8. Well Name and No.
Cone Federal #39. API Well No.
30-041-2044110. Field and Pool, or Exploratory Area
Tomahawk; San Andres11. County or Parish, State
Roosevelt County, New Mexico**12. CHECK APPROPRIATE BOX(ES) TO INDICATE NATURE OF NOTICE, REPORT, OR OTHER DATA**

**Proposed Plugging Procedures
Cano Petro of New Mexico, Inc.
Cone Federal #3
30-041-20441**

**Cone Federal 3
30-041-20441
Tom R. Cone
May 7, 2024
Conditions of Approval**

Cano Petro of New Mexico, Inc.
Cone Federal #3
API 30-041-20441
WBD Before PA

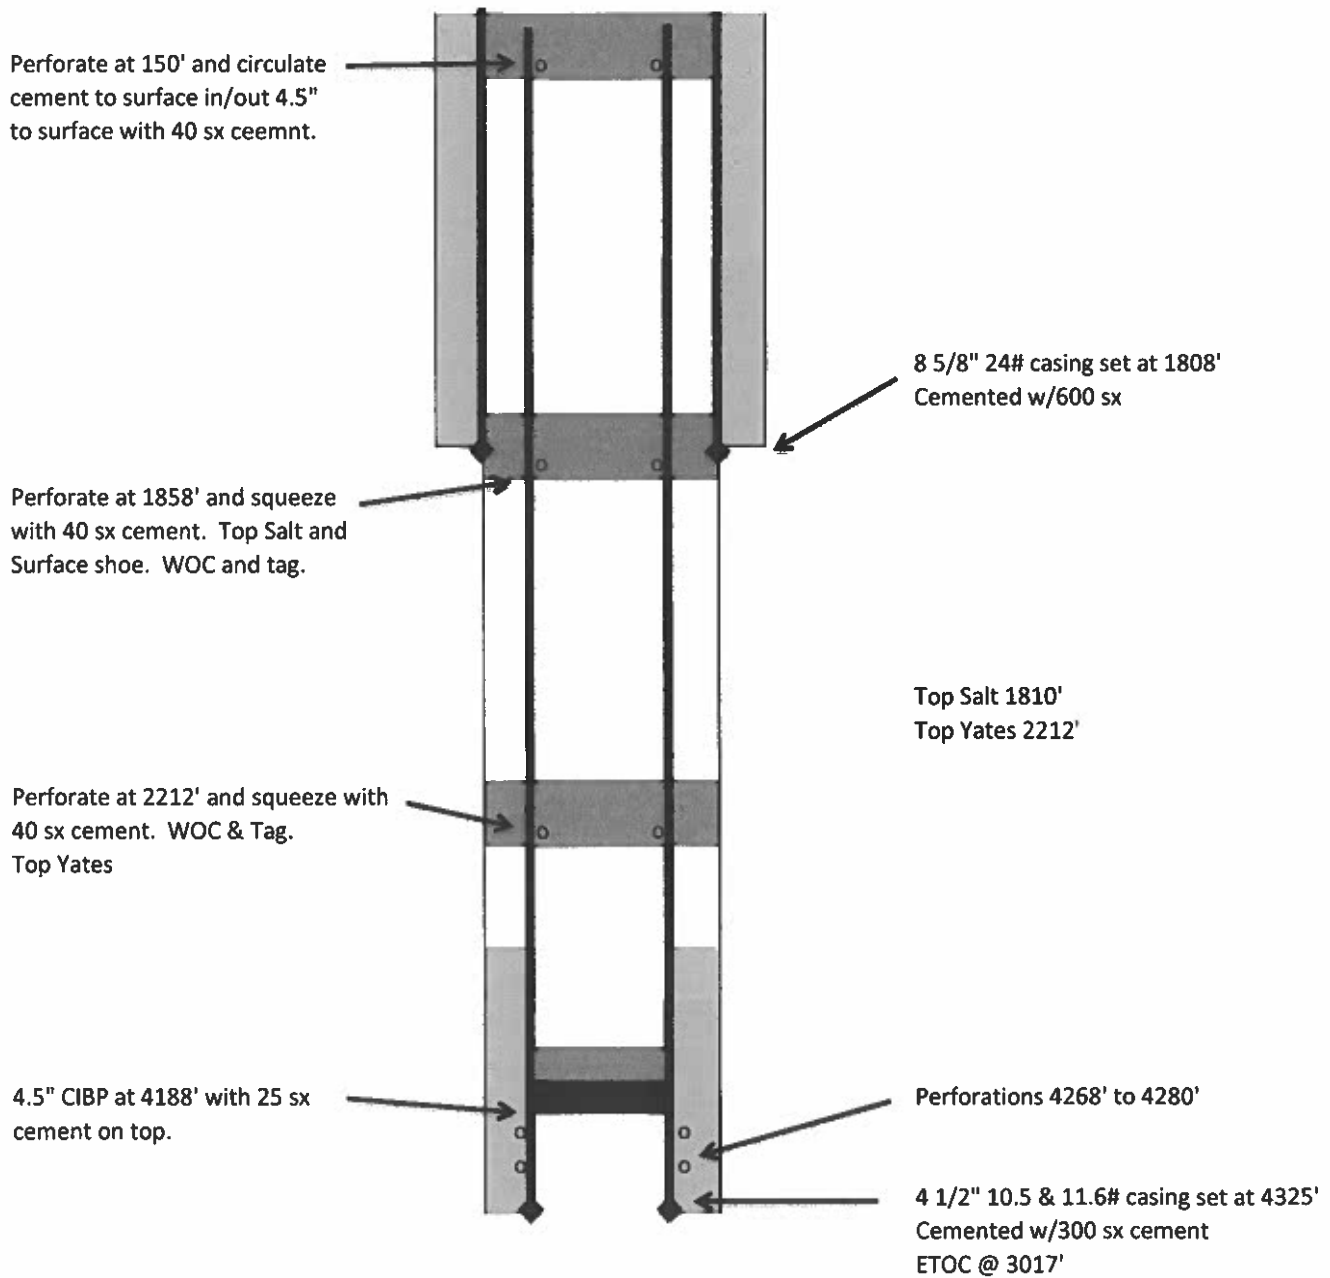
- 1. Operator shall place a CIBP at 4,188' (50'-100' above top perf) and place 25sx of Class C cement on top. WOC and TAG.**
- 2. Operator shall place a balanced Class C Cement plug from 3,170'-2,932' to seal the Queen and Grayburg Formations.**

- 3. Operator shall perf at 2,262' and squeeze cement class C cement to 2,130' to seal the Yates and bottom of Salt. WOC and TAG.**
- 4. Operator shall perf at 1,865' and squeeze cement class C cement to 1,716' to seal the top of Salt, Rustler and 8-5/8" casing shoe. WOC and TAG.**

- 5. Operator shall perf at 150' and squeeze cement class C cement to surface as proposed.**
- 6. Dry hole marker must be below ground.**
- 7. Surface reclamation will need to be completed once the well bore has been plugged. Please contact rflores@blm.gov for additional information.**
